MIL-PRF-44466A
AMENDMENT 1
24 November 1999

PERFORMANCE SPECIFICATION

HEATER, WATER AND RATION (HWR)

This amendment forms a part of MIL-PRF-44466A, dated 25 April 1997, and is approved for use by all Departments and Agencies of the Department of Defense.

FIGURE 1. Interface requirements for heater, water and ration (HWR)

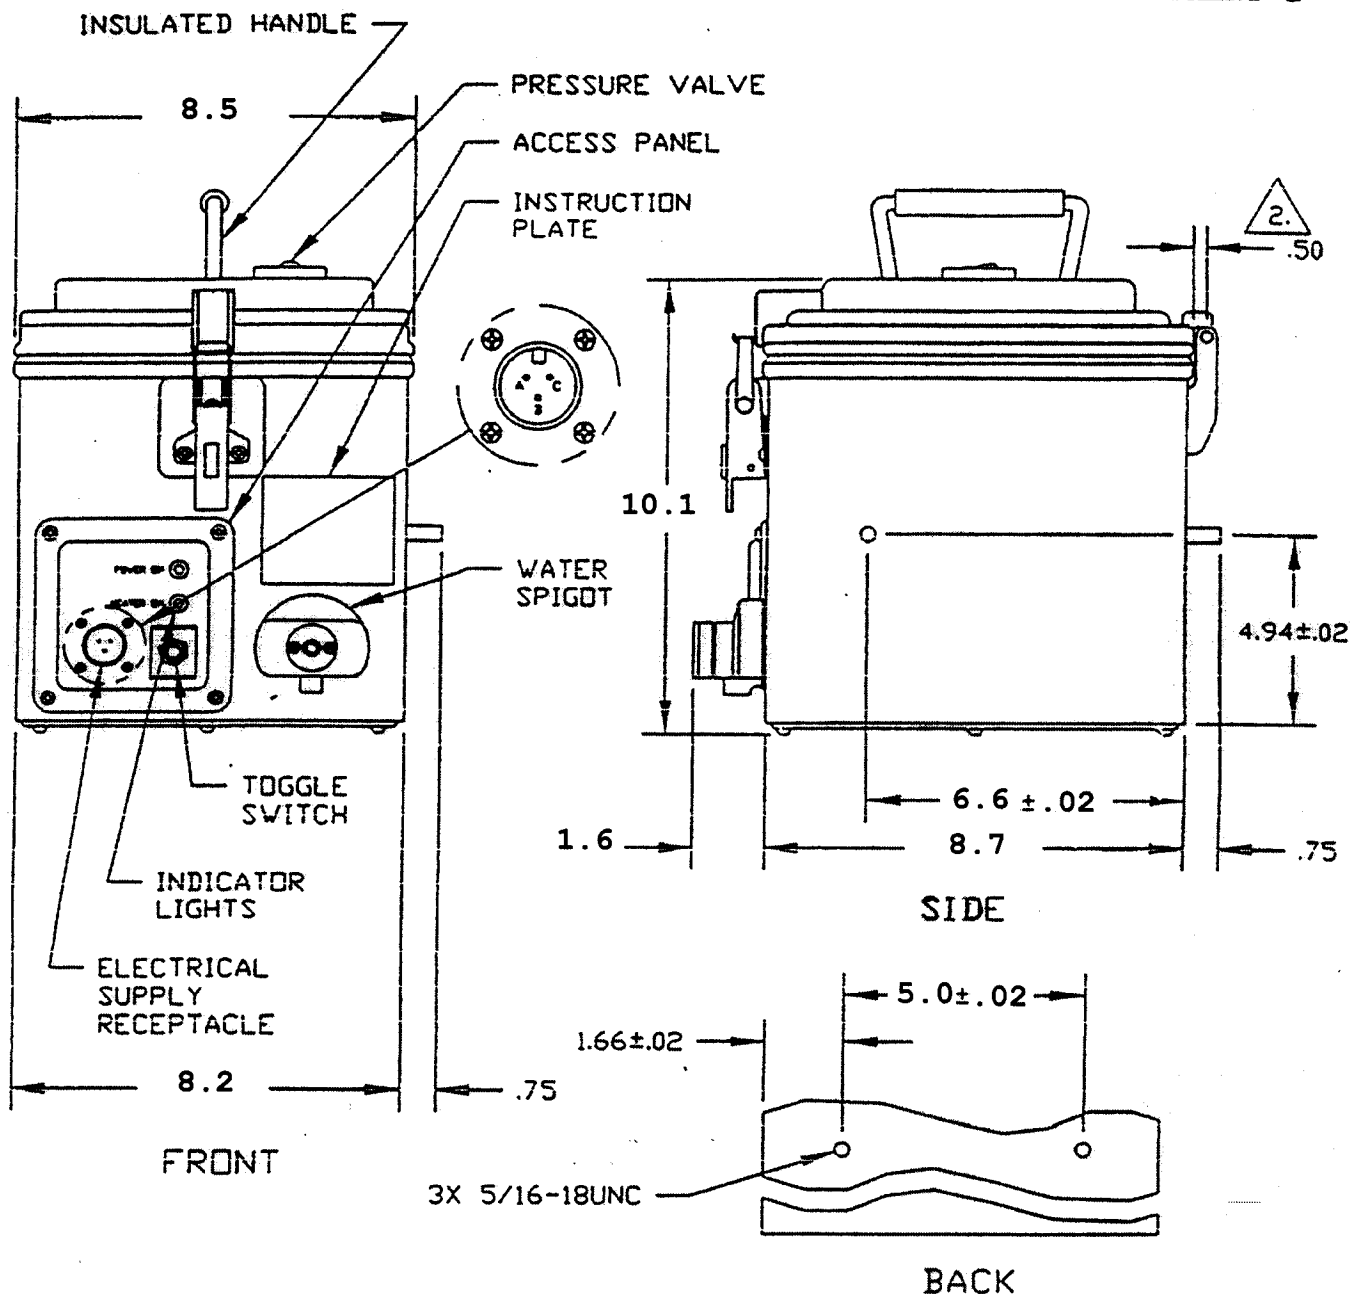
Delete "FIGURE 1.", and substitute attached "FIGURE 1.".
